Site Accessibility Evaluation

**Street A @ Street B
PU19-0044**

Public Right of Way

Street A @ Street B - Southwest Corner - Ramp 1

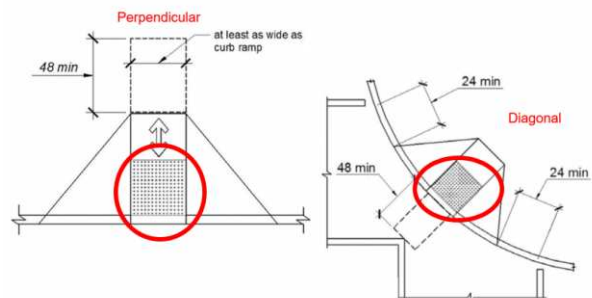
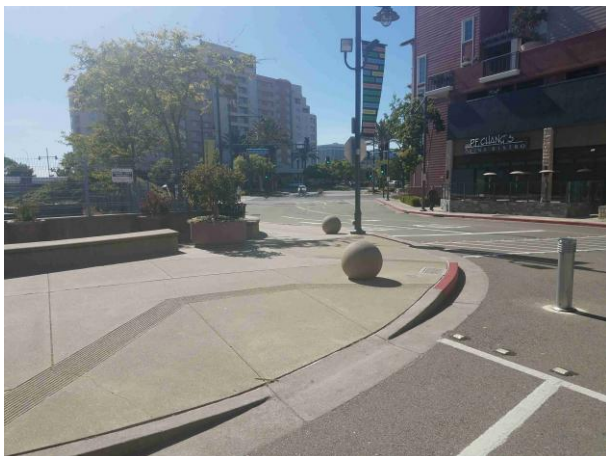
Finding: 1

The detectable warning is missing at the curb ramp.

Detectable warnings at curb ramps shall extend the full width of the ramp run less 2 inches maximum on each side, excluding any flared sides and 36 inches in the direction of travel.

2019 CBC 11B Section: 11B-247.1.2.2,
11B-705.1.2.2

Missing

Street A @ Street B - Southwest Corner - Ramp 2

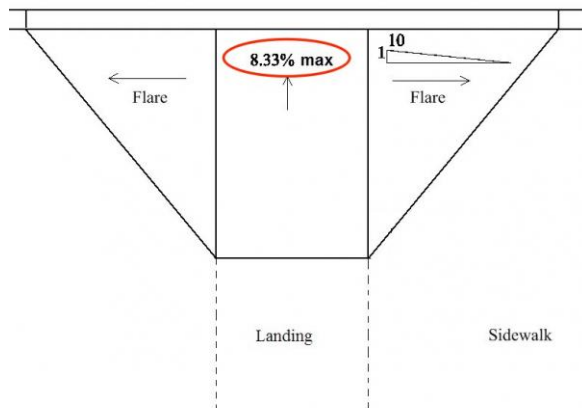
Finding: 2

The curb ramp slope exceeds the maximum running slope (Parallel to the direction of travel) allowable of 8.33%.

Curb ramps should have the least possible slope but in no case more than 8.3% (1:12).

2019 CBC 11B Section: 11B-406.3.1

8.5% to 12.3%

Street A @ Street B - Southeast Corner - Ramp 2

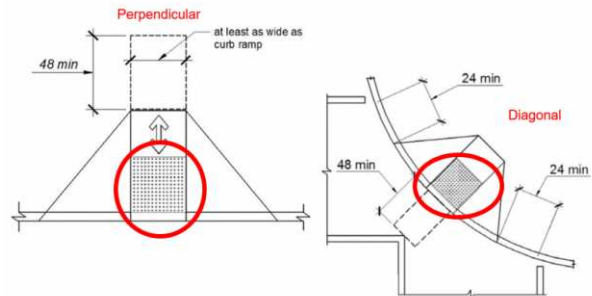
Finding: 4

The detectable warning is missing at the curb ramp.

Detectable warnings at curb ramps shall extend the full width of the ramp run less 2 inches maximum on each side, excluding any flared sides and 36 inches in the direction of travel.

2019 CBC 11B Section: 11B-247.1.2.2,
11B-705.1.2.2

Missing

Path of Travel from Street A to Street C - Northbound

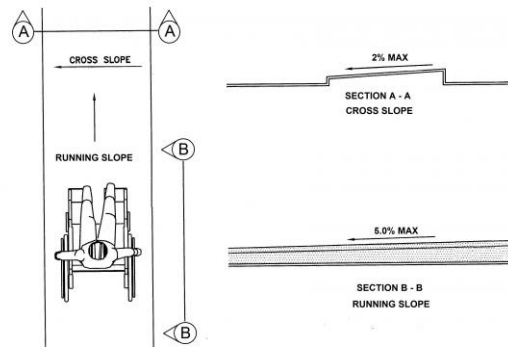
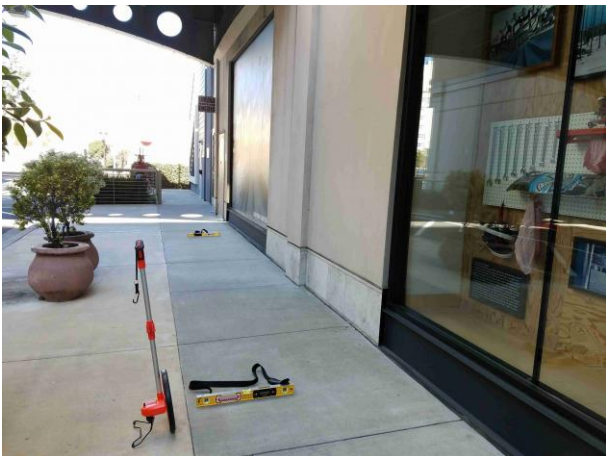
Finding: 5

The accessible path of travel contains cross slopes greater than 2%.

Surface cross slopes shall not exceed one unit vertical in 48 units horizontal (2-percent slope). When the slope in the direction of travel of any walk exceeds 1 unit vertical in 20 units horizontal (5-percent slope), it must be constructed as ramp.

2019 CBC 11B Section: 11B-403.3

3.5% to 4.5% (5 panels)

Path of Travel from Street A to Street C - Northbound

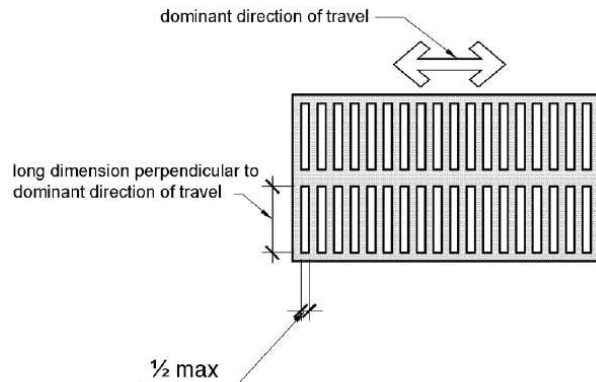
Finding: 6

The concrete expansion joint is spaced greater than 1/2 inch.

Openings in floor or ground surfaces shall not allow passage of a sphere more than 1/2 inch diameter. Elongated openings shall be placed so that the long dimension is perpendicular to the dominant direction of travel.

2016 CBC 11B Section: 11B-302.3

1/2 inch to 3/4 inch
(Typ)
